**Bridge Factors Factual Report Attachment 45 – FDOT Structures Design Office (SDO)
electronic review and email comments on submittal phases for the signature pedestrian
bridge**

HWY18MH009

434688-1: FIU UNIVERSITY CITY PROSPERITY PROJ. ALONG SW 109 AVE & SR 90/SW 8 ST

CANOPY END DIAPHRAGM DIMENSIONS & P.T. - TYPE II
UNIVERSITYCITY PROSPERITY PROJECT
SHEET NO. B-54

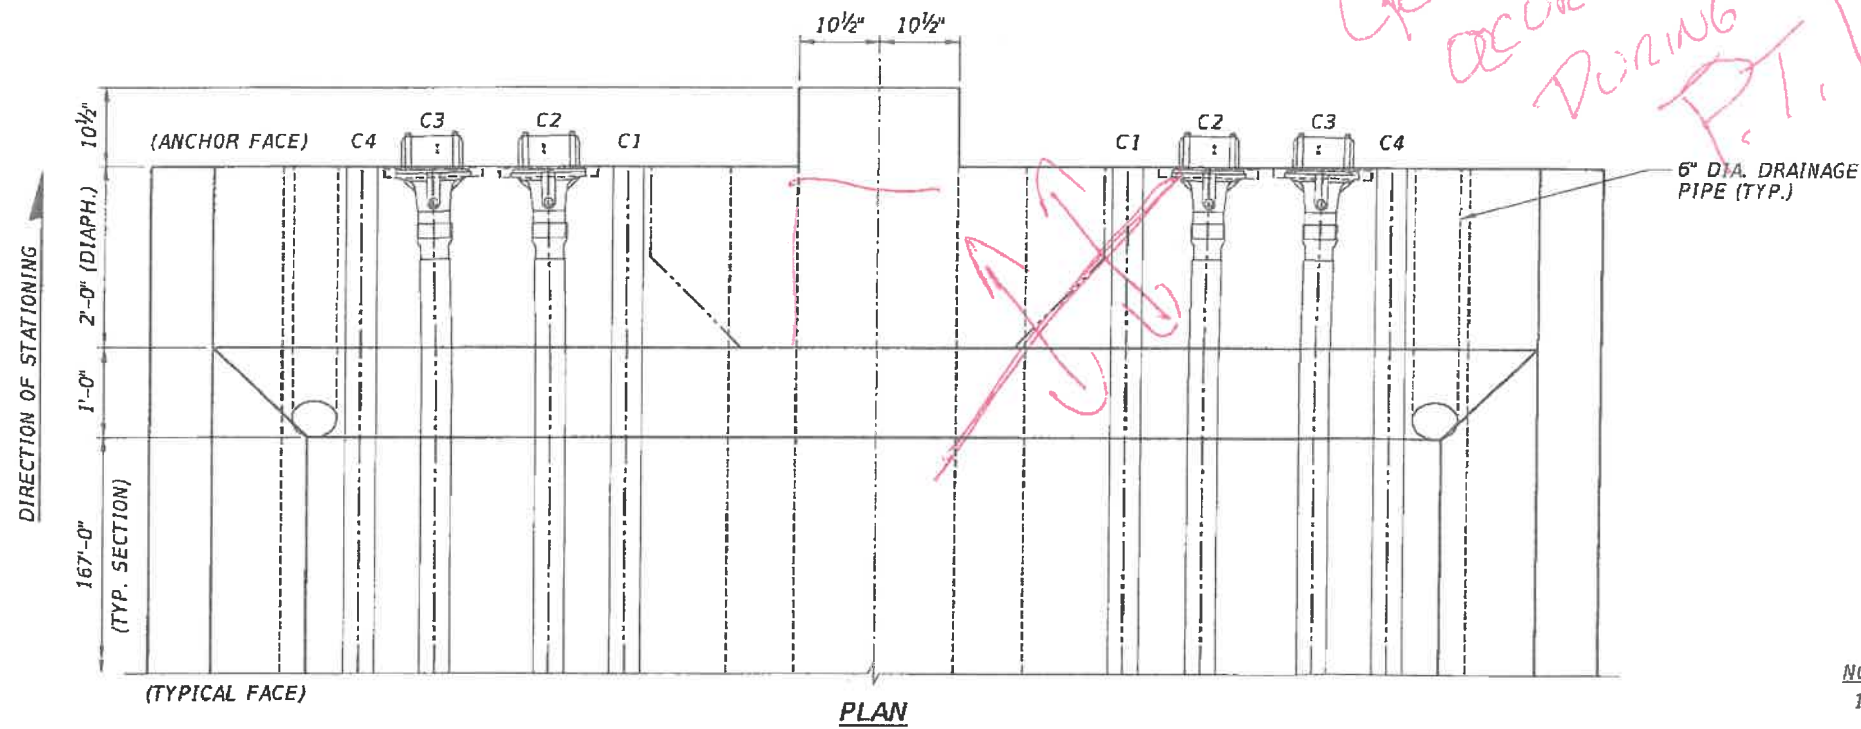
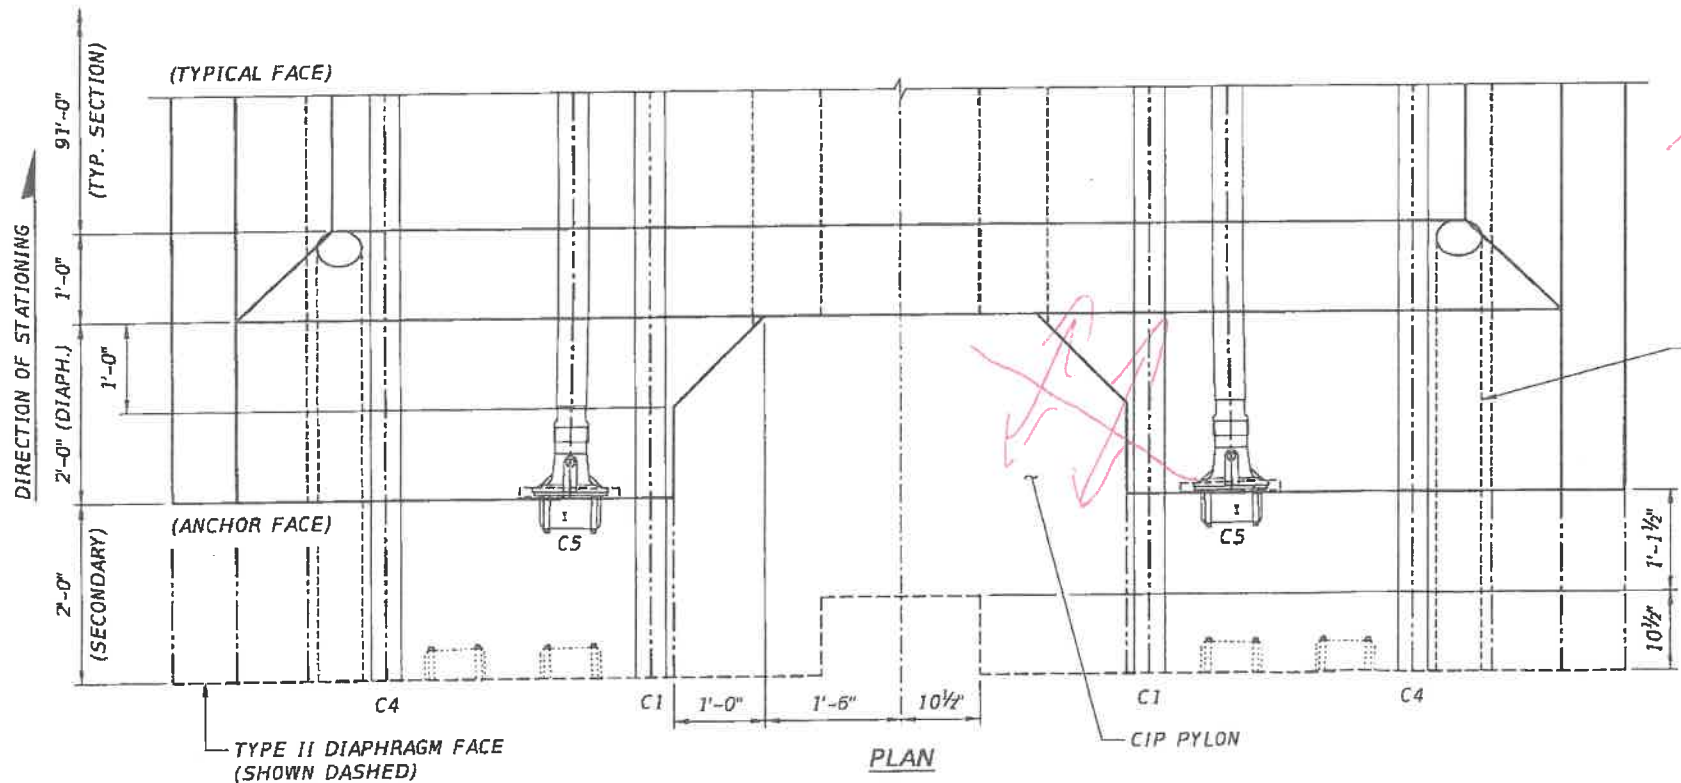
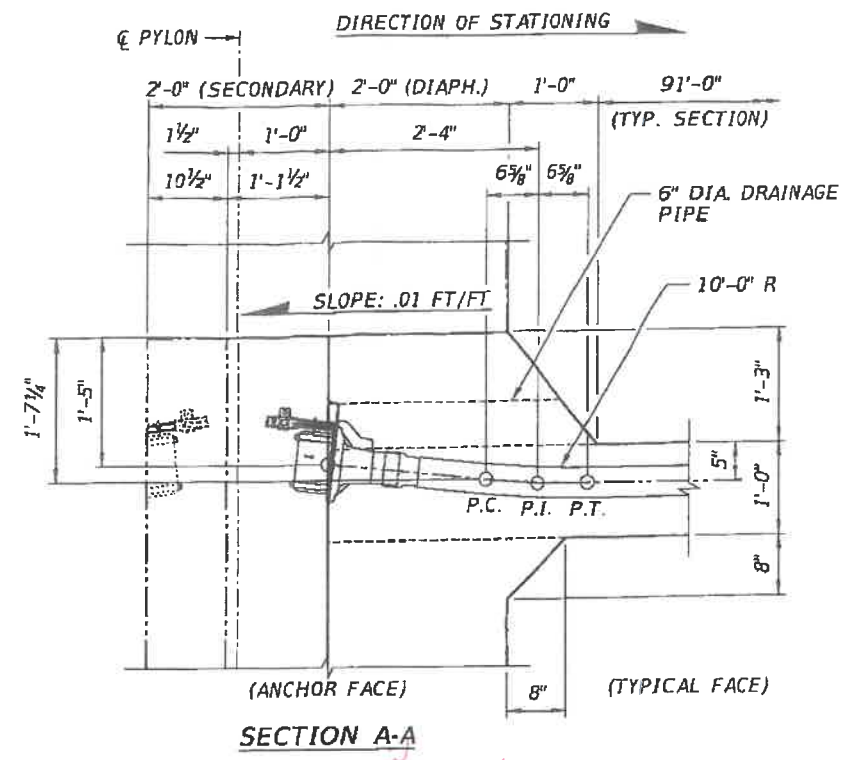
CRACKING WILL OCCUR HERE DURING PHASE I P.T.!!

REVISIONS				ENGINEER OF RECORD:		DRAWN BY:		PROJECT TITLE:	
DATE	BY	DESCRIPTION	DATE	BY	DESCRIPTION	DATE	BY	DESCRIPTION	DESCRIPTION
									CANOPY END DIAPHRAGM DIMENSIONS & P.T. - TYPE III
									UNIVERSITYCITY PROSPERITY PROJECT
									SHEET NO. B-56

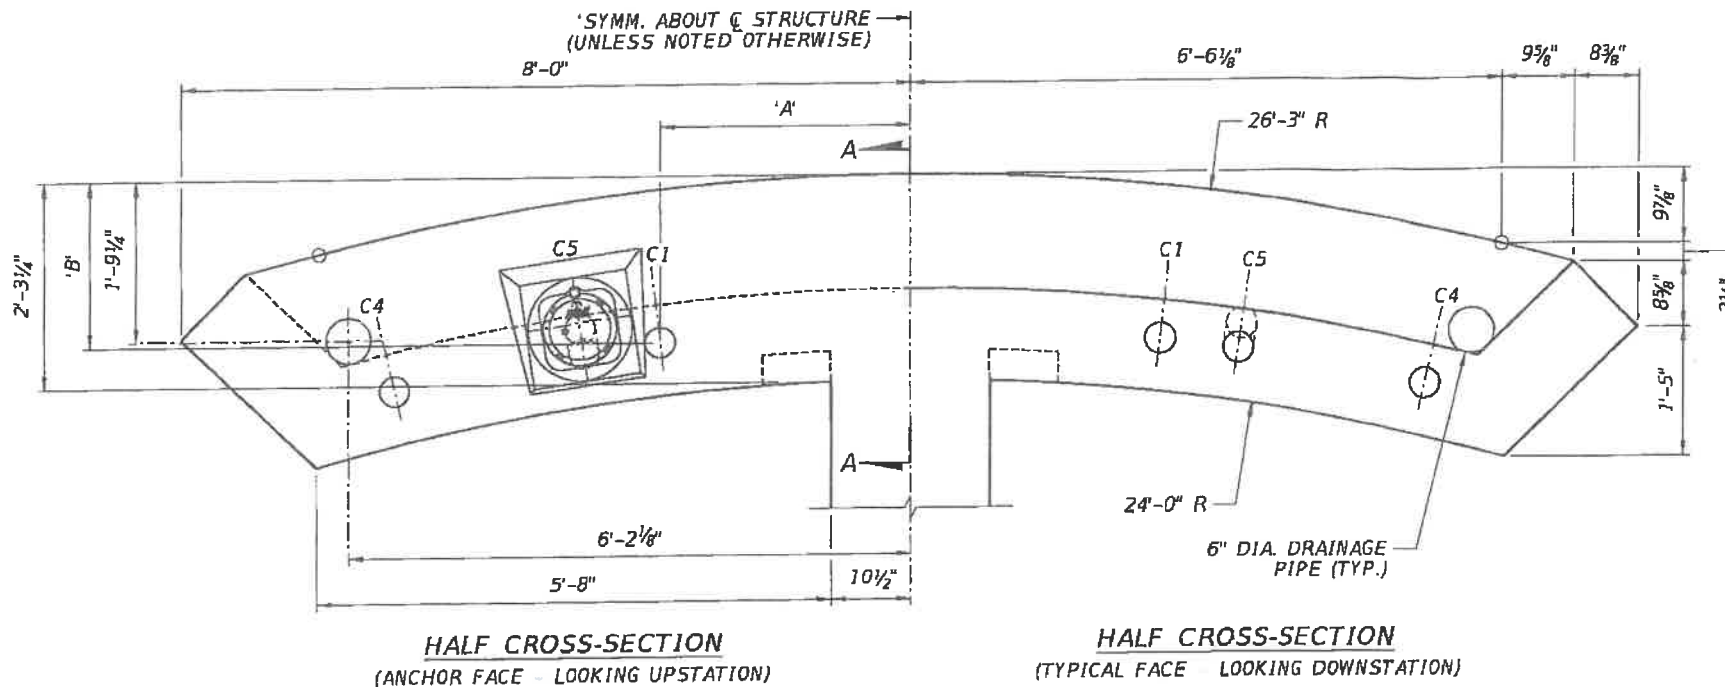
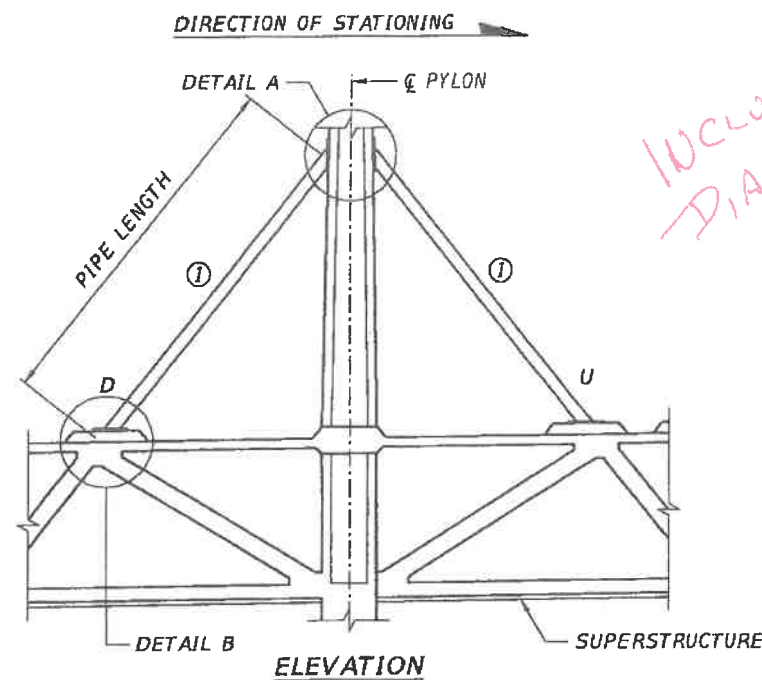
DIAPHRAGM PYLON... ISOCATE DURING SAW FABRICATION A STAGE I STRESSING.

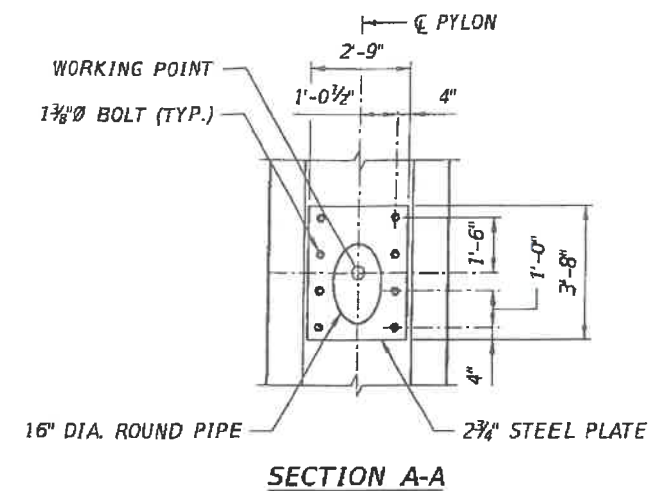
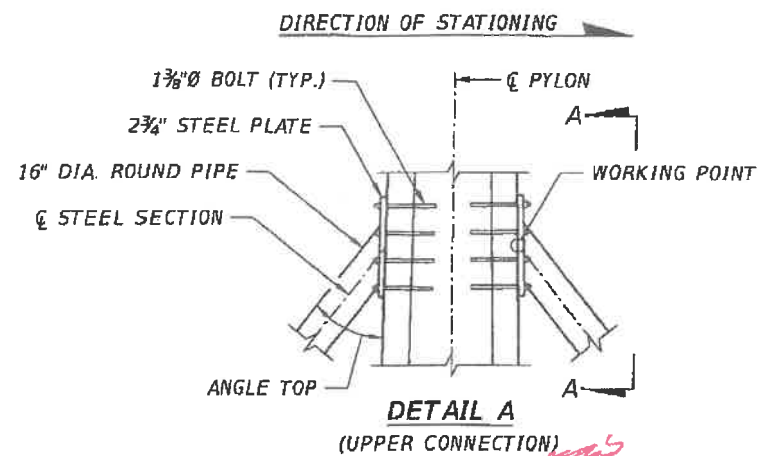
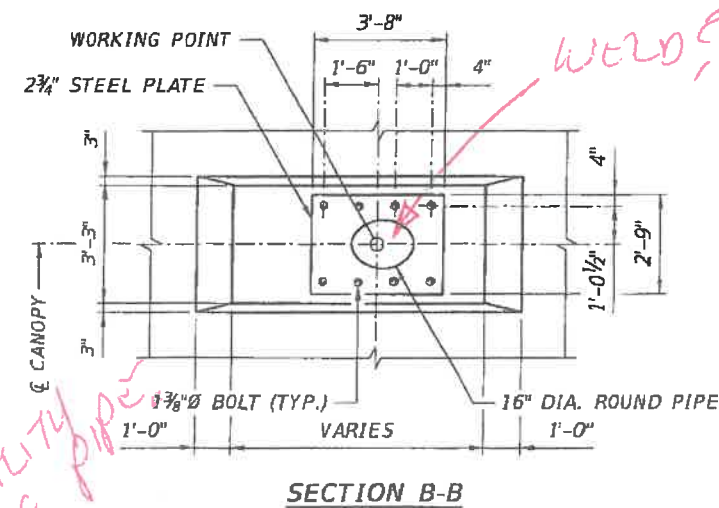
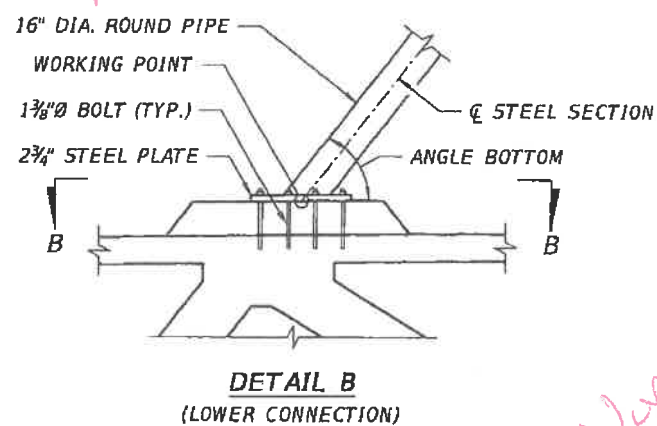
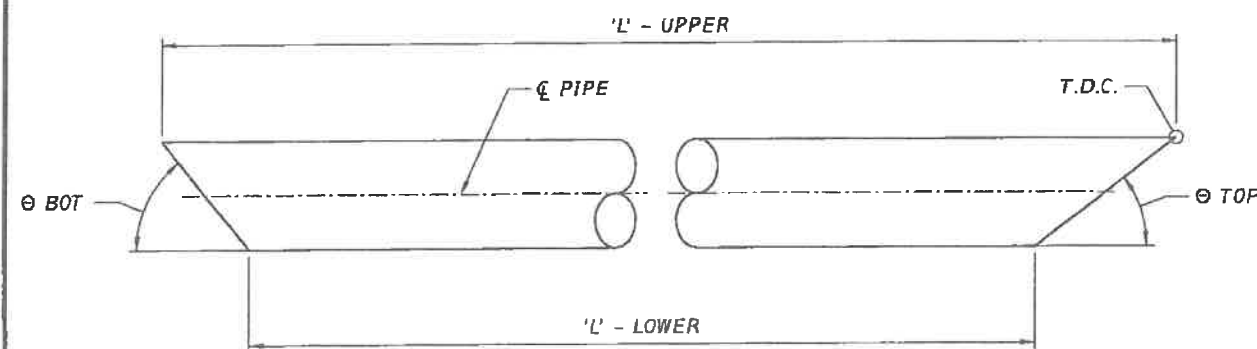
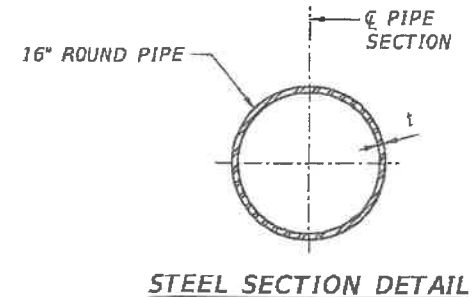
INCLUDE CAMBER DIAGRAMS.

INCLUDE HIGH PERFORMANCE PAINTING SYSTEM GENERAL NOTE. — A

Verify Availability of Pipe
